AGENDA
PLANNING AND ZONING COMMISSION MEETING
CITY OF CREVE COEUR, MISSOURI
MONDAY, MARCH 16, 2015
7:00 PM

APPLICATION TO PLANNING AND ZONING COMMISSION #15-001 FOR SITE DEVELOPMENT PLAN OF AN OFFICE BUILDING AT 844 N. NEW BALLAS COURT

REQUEST: An application has been submitted for a new 16,467 sq. ft., three-story office building at the southeast corner of East Rue De La Banque and North New Ballas Court. The Applicants are seeking a site coverage bonus for the proposed 69.3% site coverage by providing seating and landscaping. Changes since the prior Staff Report, include revising the building materials, angling the entrance to be more oriented toward the street, and providing two site plans with and without the vacation of the easement.

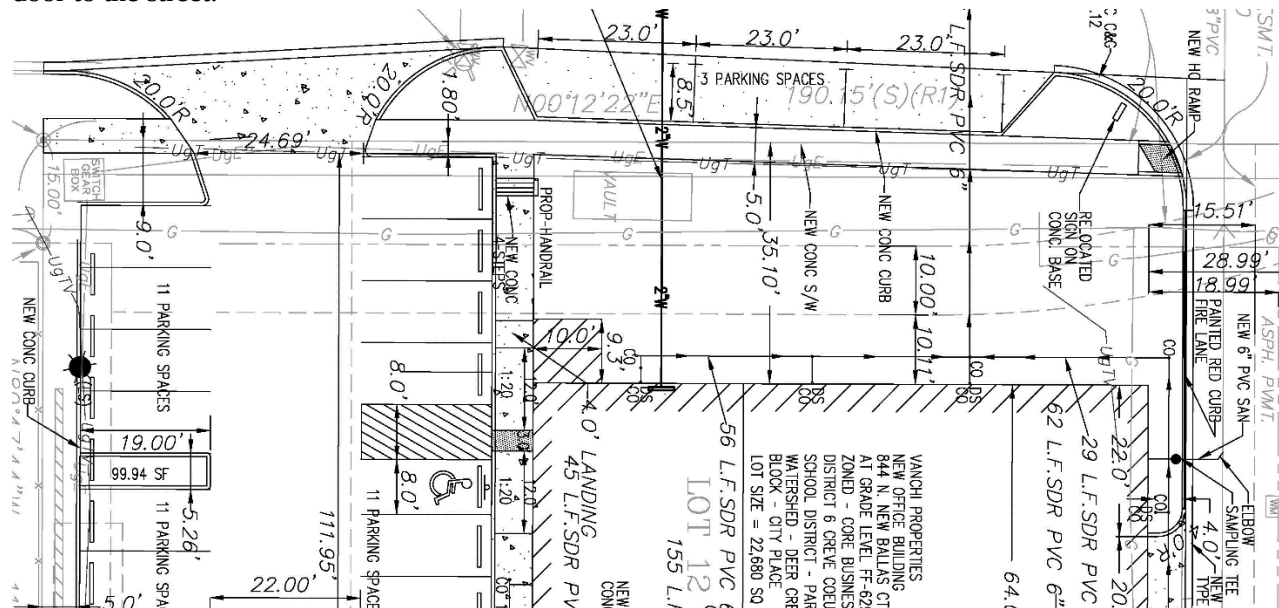
1. The building entrance has been angled to provide better orientation to E. Rue de la Banque, providing a proper door-yard, and an architecturally integrated canopy has been included to provide a stronger visual delineation of the entrance.

2. The revised materials of the building consist of brick and split-face block, and architectural panels for the second and third floor in the effort to increase the quality of the building materials. Architectural details include providing a belt line along between the ground and first floor, and first and second floors, as well as providing corbels at the roof, for greater pedestrian and design interest. However, there seems to be a lack of a distinct design style, where the Design Guidelines recommend incorporating a clear and well-articulated design concept.

Figure 3: Proposed Site Plan with Easement Vacated.

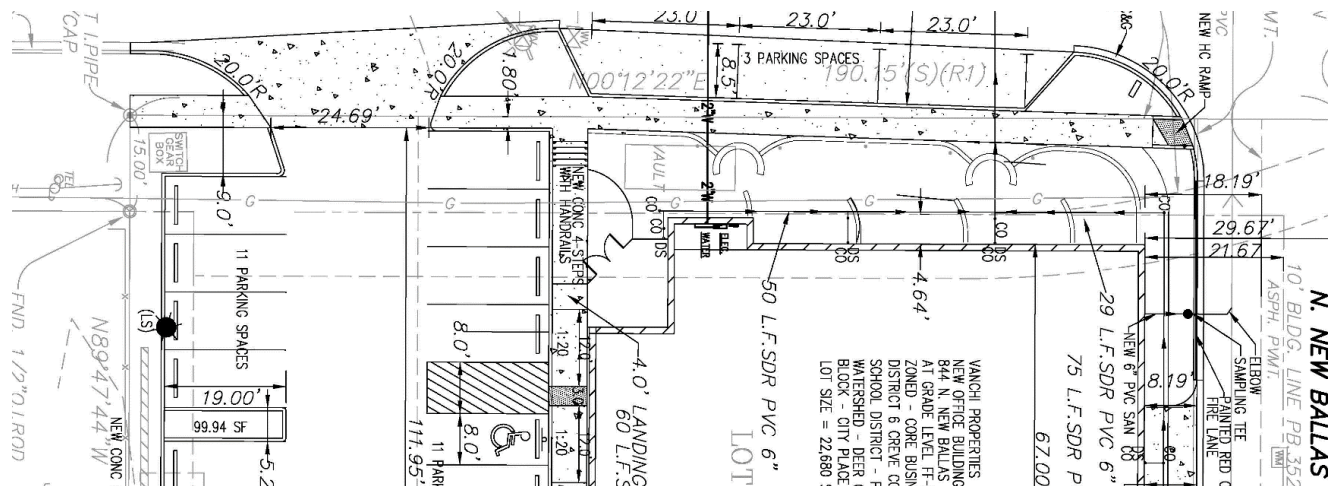
4. **Building Setback:** As discussed in the prior Staff Report, the CB Zoning District requires that 50% of the building be a maximum distance from E. Rue De La Banque of 15 feet. The one site plan maintains the previously reviewed setback of 35.10 feet from East Rue de la Banque Street due to the easement on the property. The second site plan shows the proposed location with the elevator tower at the 15-foot setback and the remainder of the building at approximately 19.5 feet from the property line should the Applicant receive approval to vacate the easement. It appears that a gas line is just on the inside of the 15-foot setback, therefore it is unlikely that the building can be built any closer to the road with this option, if the tower element is to remain. The Applicants have not indicated if they have had the utilities properly marked to determine the status of the easement at this time.

5. The Applicants have set the building from N. New Ballas Court 8.19 feet to provide for a sidewalk and landscaping next to the building to further comply with the Design Guidelines, although the neighbors request that it be setback 15 feet. Staff recommended a minimum 10-foot offset between the road and the entryway to allow for proper viewing of oncoming traffic. Further recessing the garage entry could provide some interest to this side of the building.

7. The Applicant shall submit evidence from the appropriate utility authorities documenting that the easternmost 10-foot utility easement along E. Rue de la Banque cannot be vacated. Based upon sufficient evidence, the Zoning Administrator shall be authorized to approve the site plan with the building at the 35.10-foot setback from E. Rue de la Banque in substantial conformance with the "Grading Plan" and "Civil Site/Striping Plan" submitted on March 10, 2015 as bound together and submitted in conjunction with Application #15-001 by Jack Whaley, Architect.

Designed: L.T.	GRADING PLAN	
Drawn: WC	THOMPSON CIVIL, LLC 5337 GLADSTONE AVE., STE #1 ST. LOUIS, MISSOURI, 63121	Date: FEBRUARY 2015
Checked: L.T.	PHONE: 314-724-3127	Sheet: C5

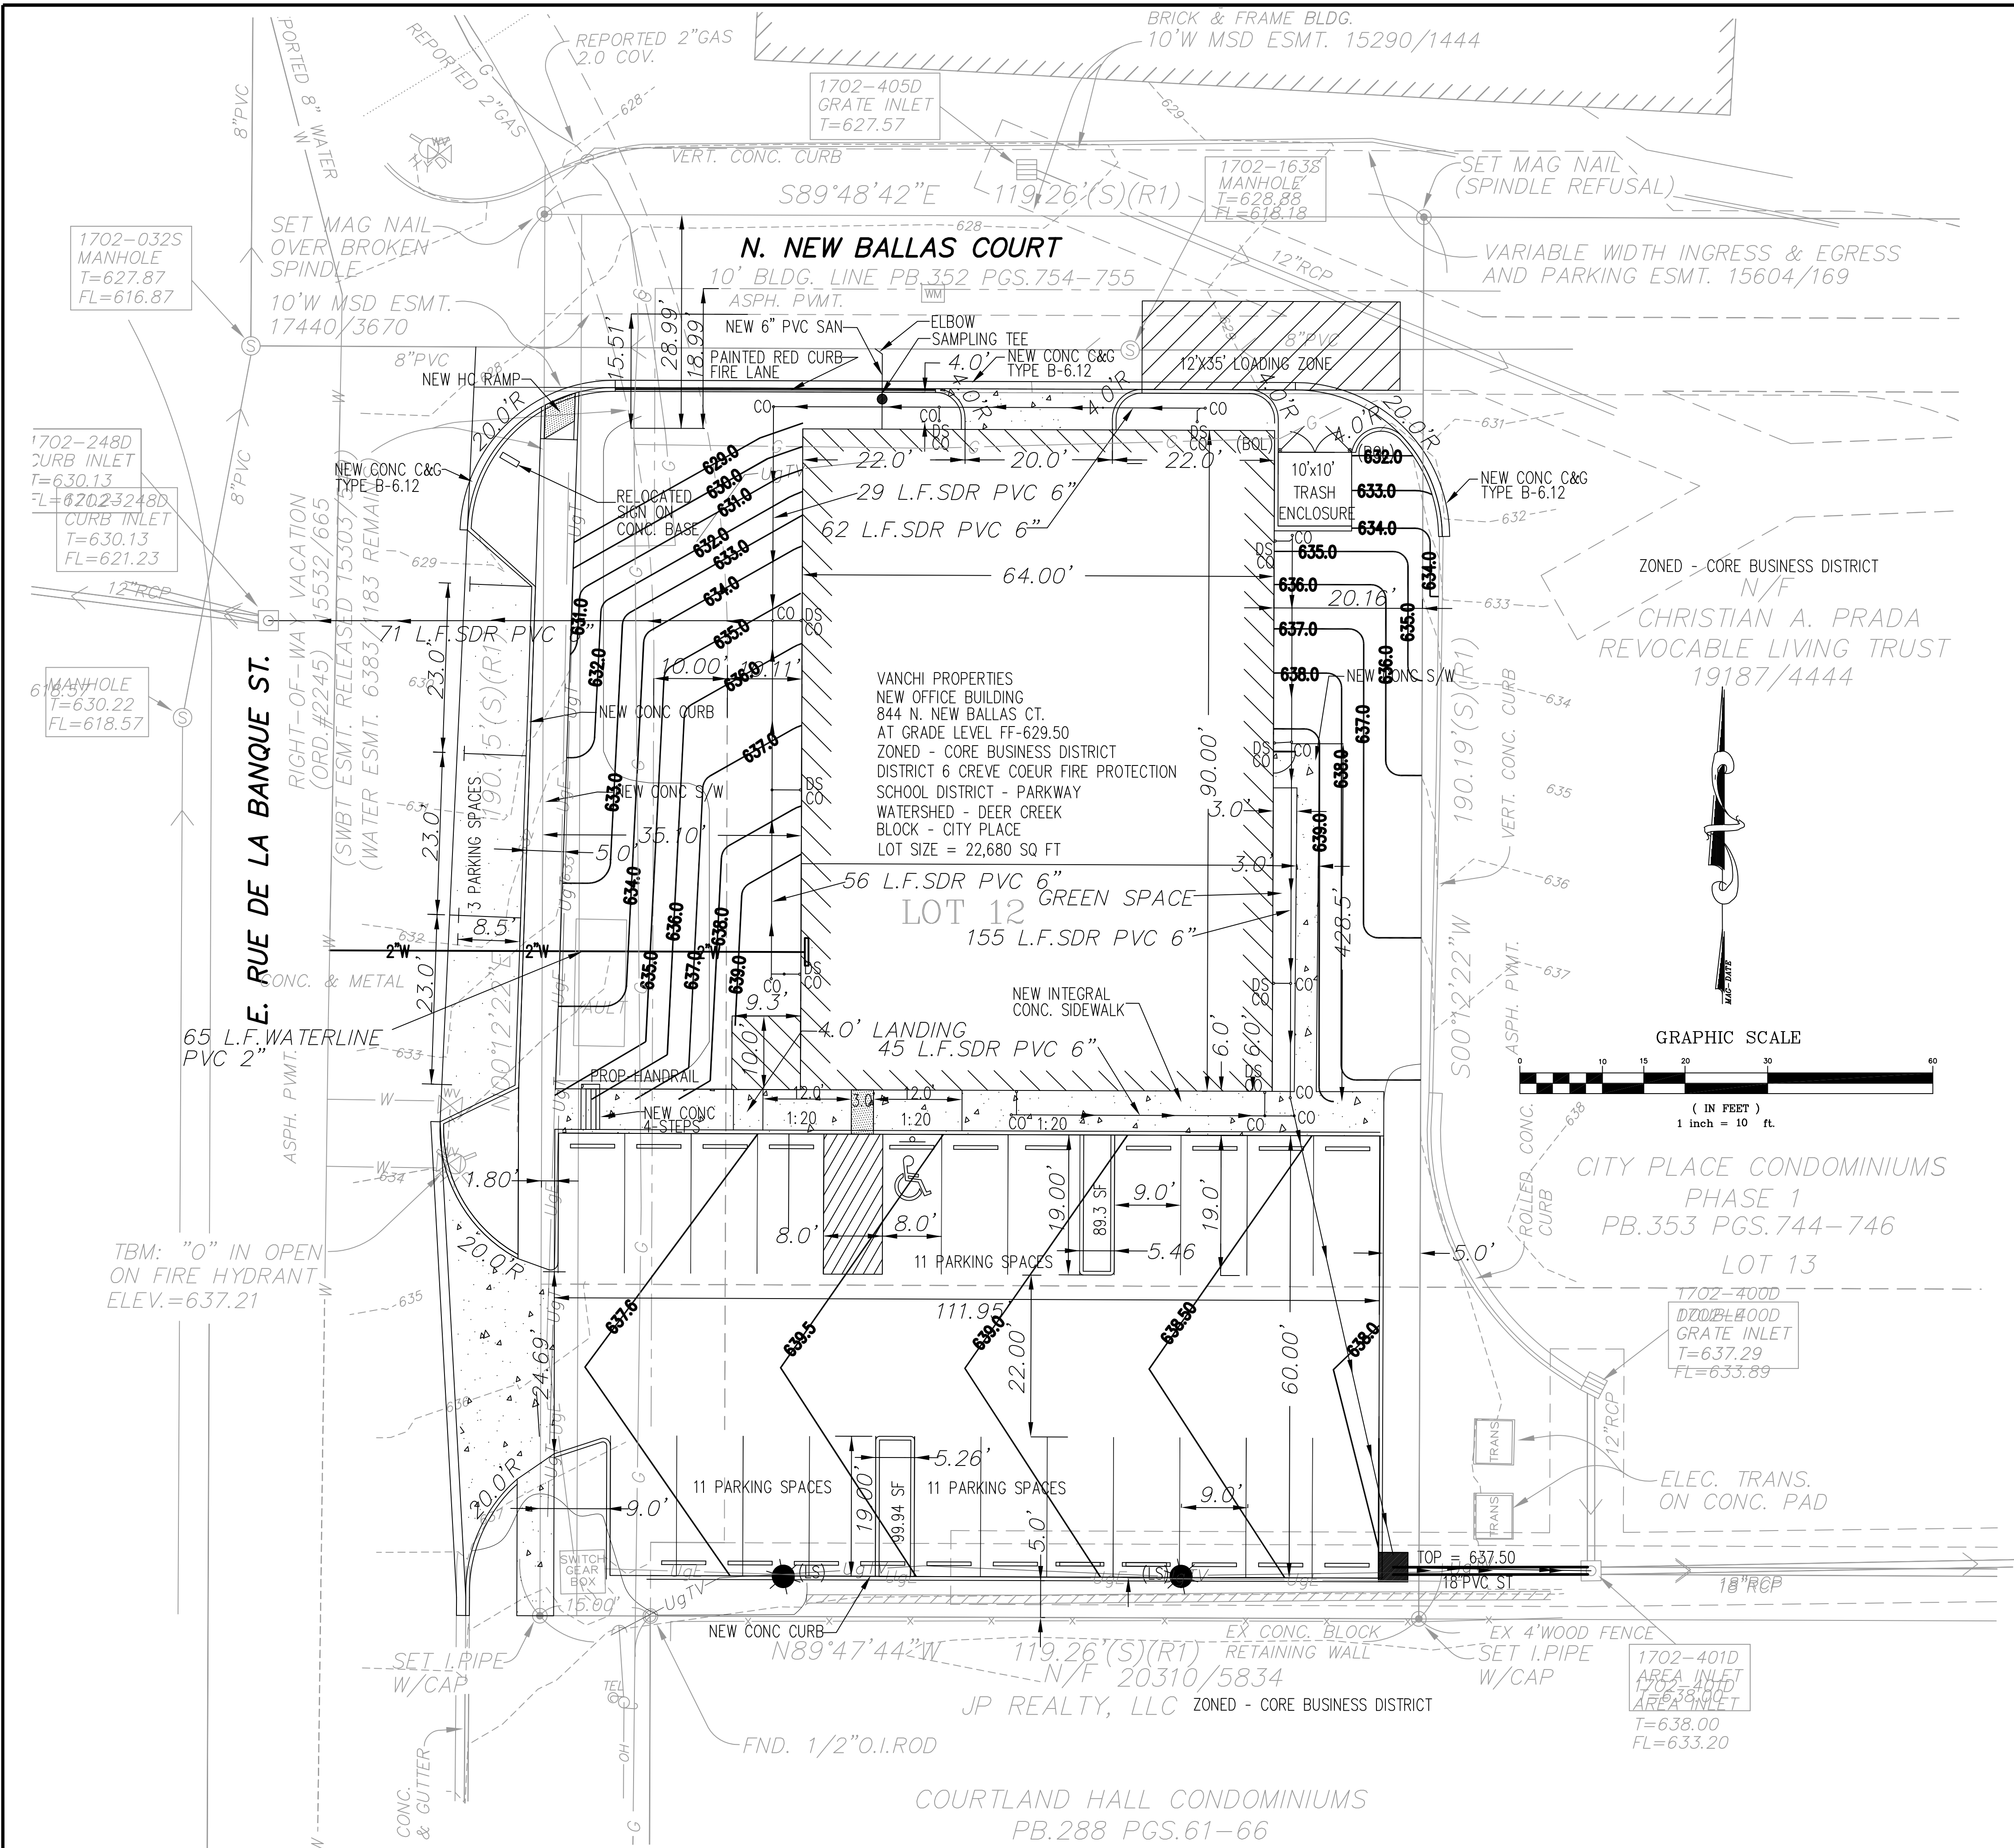
3. The grading plan does not match up with the landscape plan provided. These need to be clarified and a related condition of approval is recommended. Further two dimensions scales are shown on the plans, Staff is unable to verify the correct dimension, since the drawing scale does not match the graphic scale.

5. The Applicant shall revise the grading plan to reflect the proposed retaining walls shown in the landscape plan for the Zoning Administrator's approval. The top and bottom elevations of all walls shall be included.
